POST-HANDOVER INSPECTION REPORT

Sample New-Build Home

CLIENT-ISSUE SAMPLE REPORT

Central-Heating System, ADEY ProCheck Analysis

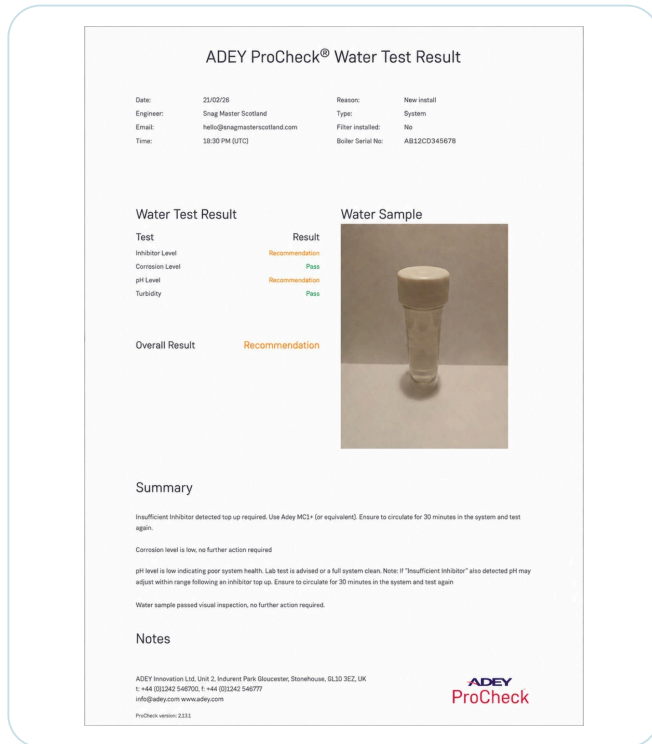
The ADEY ProCheck result records an overall Recommendation, with inhibitor level and pH requiring attention while corrosion level and turbidity are recorded as Pass.

Insufficient inhibitor and an unsuitable pH can reduce corrosion protection within a wet central-heating circuit and may adversely affect long-term system condition if not corrected.

Treat the system in accordance with the ADEY result and heating-system manufacturer guidance. Restore the correct inhibitor concentration, circulate fully and retest. Investigate pH further if it remains outside the recommended range after treatment.

Ceiling Junction, Localised Thermal Anomaly

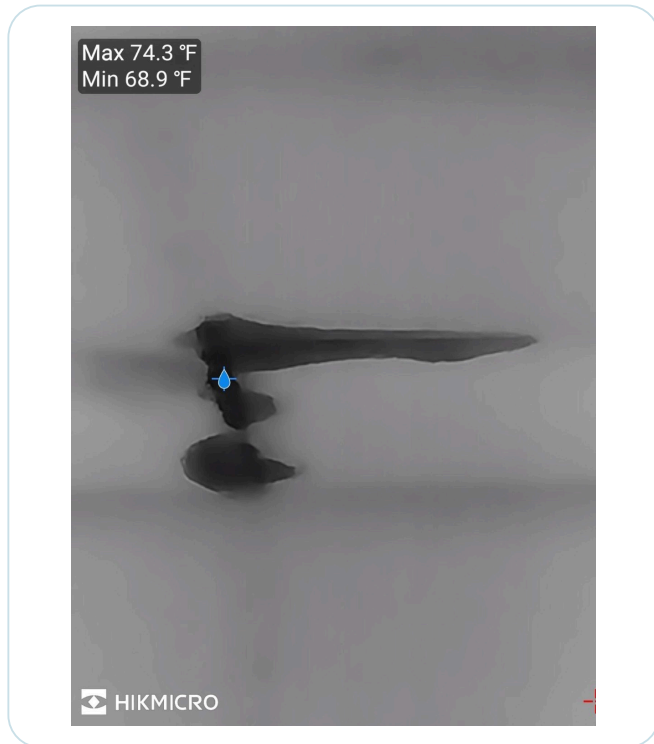
Thermal imaging recorded a pronounced localised cold anomaly at the ceiling junction. The pattern is indicative only but is consistent with possible concealed moisture or another localised thermal irregularity.

If moisture is confirmed, concealed saturation can damage plasterboard, decoration and insulation and may promote mould growth. The thermal image alone does not identify the source or prove active leakage.

Confirm the finding with appropriate moisture testing and inspect above/behind the affected area where practicable. Trace and rectify the source, dry affected materials and recheck after drying.

Radiator Assembly, Uneven Heat Distribution

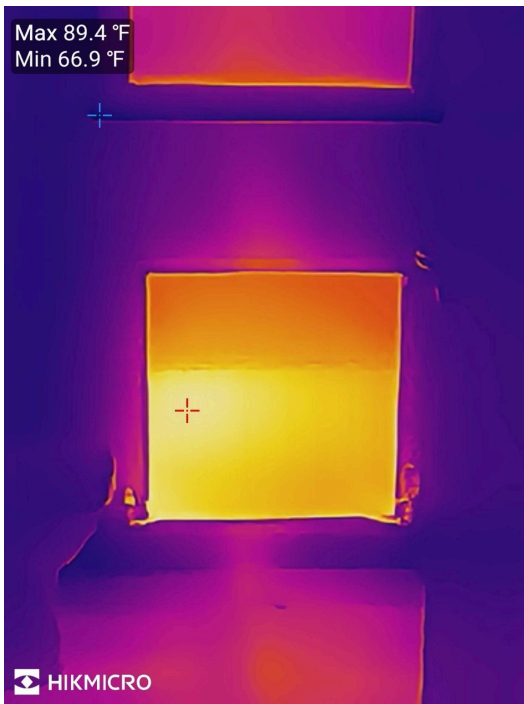
Thermal imaging shows uneven heat distribution across the radiator, with the upper section operating cooler than the lower section during the heating check.

The thermal pattern may indicate trapped air, inadequate balancing or restricted circulation, reducing emitter performance and preventing even heat output.

Bleed the radiator, check valve operation and system pressure, balance the heating circuit as necessary and repeat the heat-up test once the system has reached steady operating temperature.

External, End of Lead Abutment

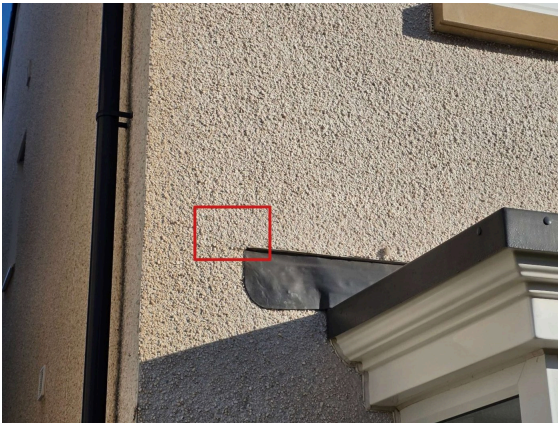
No weep vent is visible at the expected end of the stepped cavity-tray / lead-abutment drainage position.

Where the approved cavity-tray detail requires discharge at this point, missing or blocked weep provision can prevent intercepted moisture draining safely to the exterior and increase the risk of moisture tracking into the wall.

Confirm the approved cavity-tray / abutment construction and check for concealed or blocked outlets. Where required by the detail, install or reinstate the specified weep outlet, tray stop-end and clear discharge route.
